AMERICAN TEL-A-S
4800 CURTIN
McFARLAND, WISCO
(608)838-4

TITLE: H.110 BRI S/T IN

DOCUMENT NUMBER: 25888

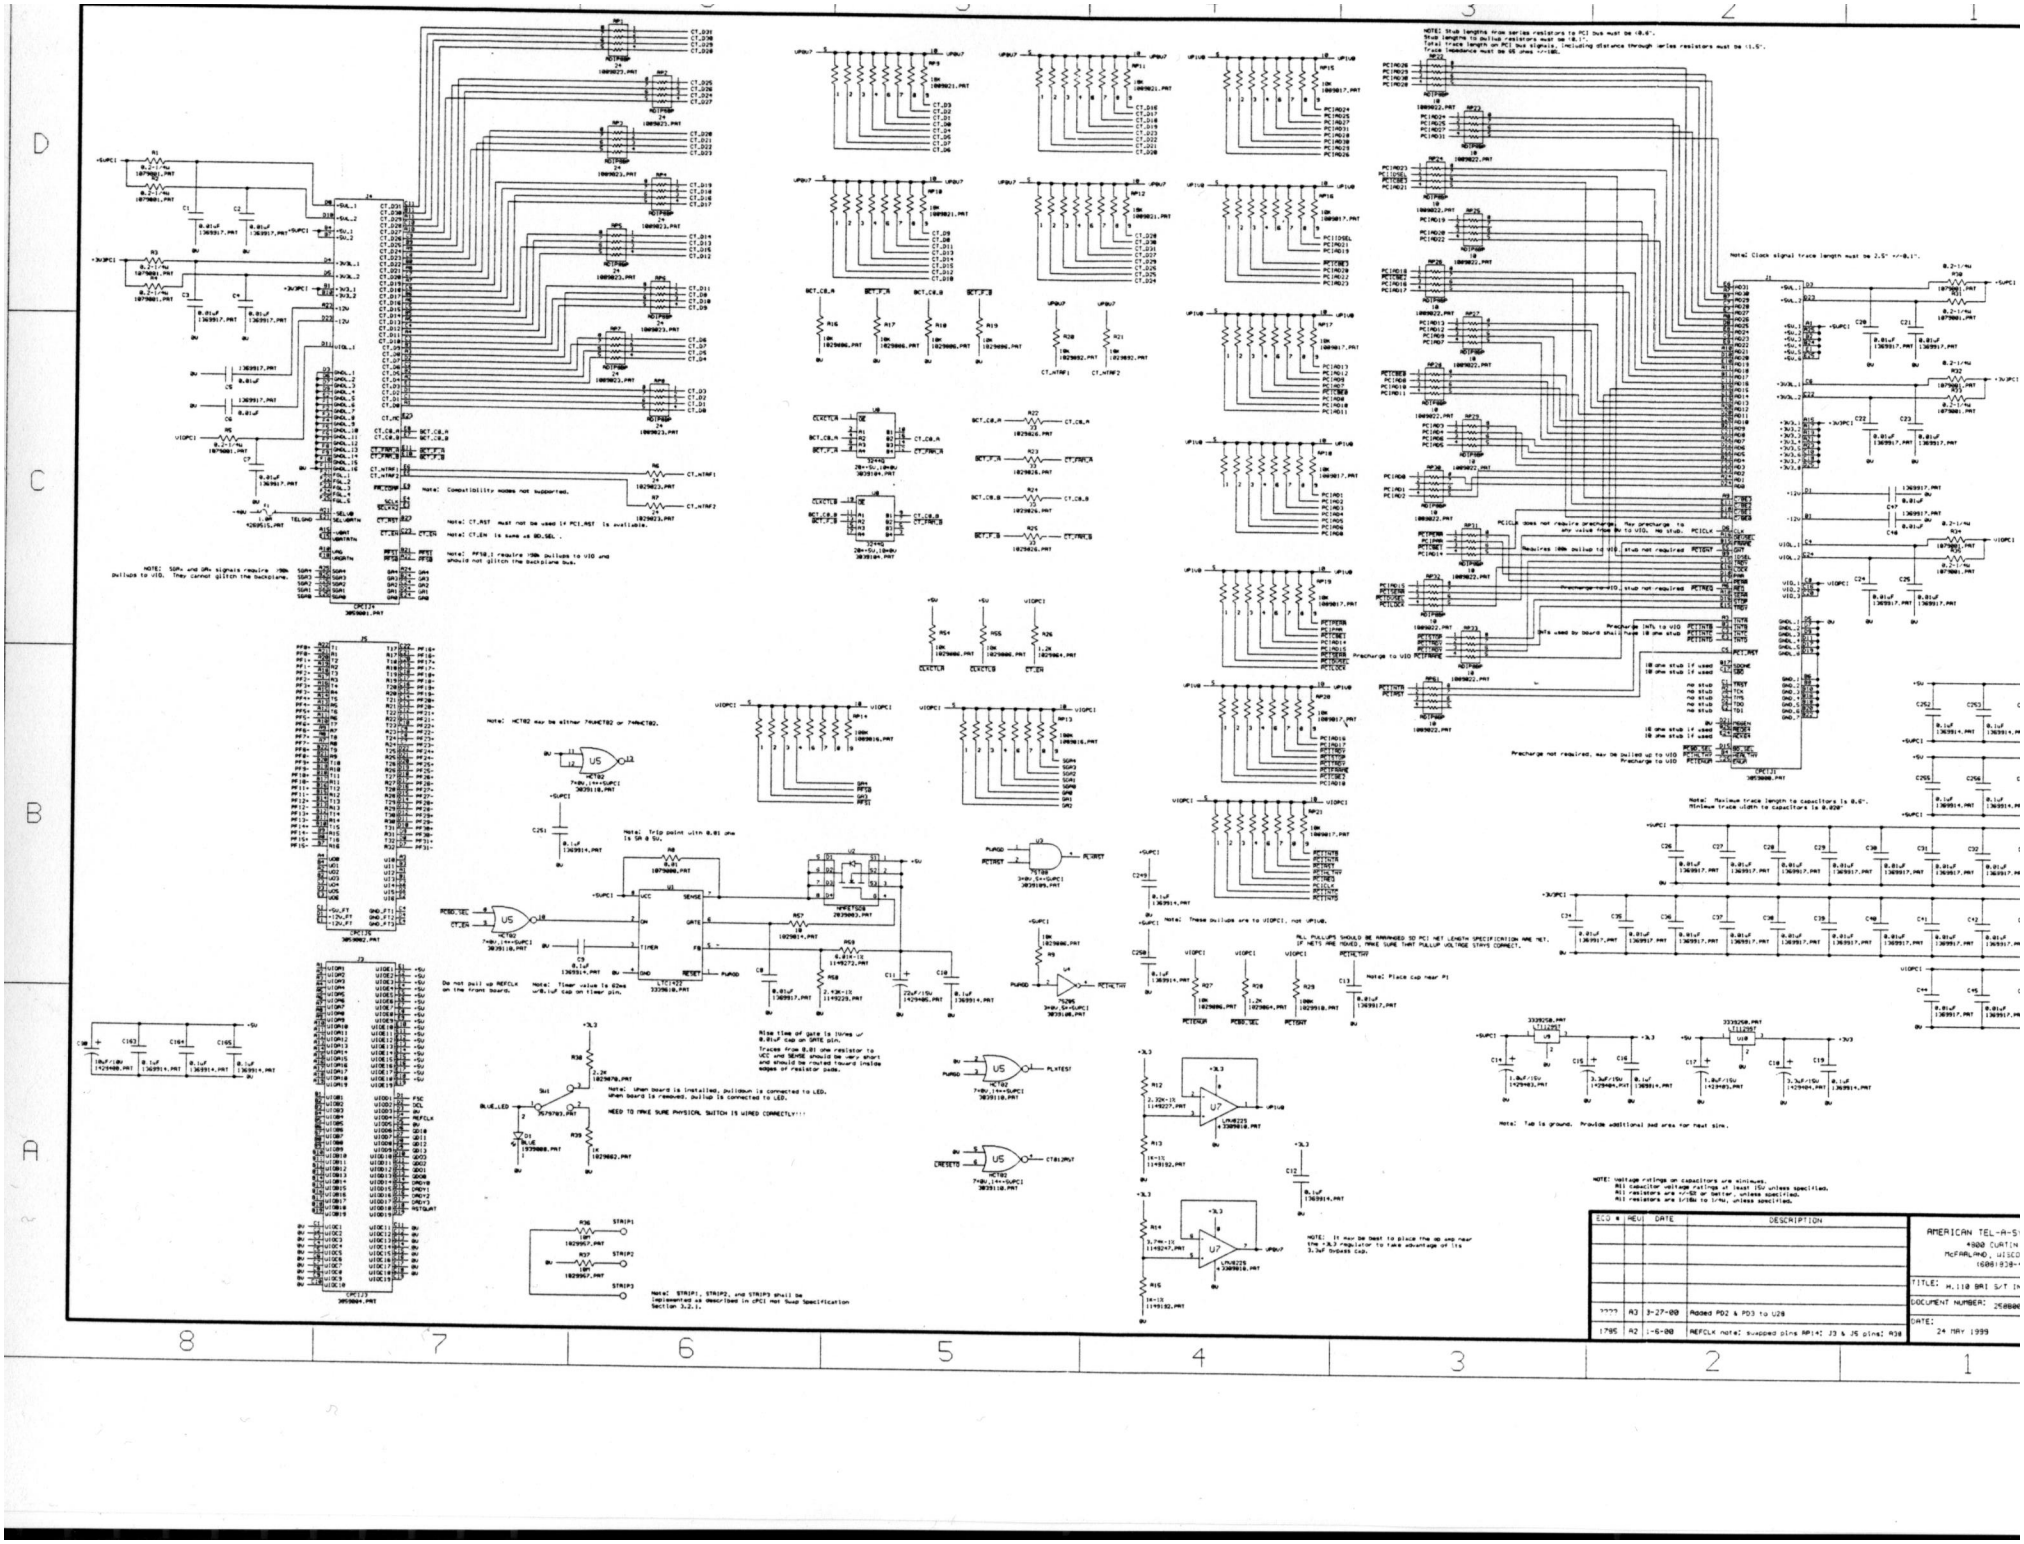
ECO #	REV	DATE	DESCRIPTION
7777	A3	3-27-00	Added PD2 & PD3 to U28
1795	A2	1-6-00	REFCLK note; swapped pins RP14; J3 & J5 pins; R38
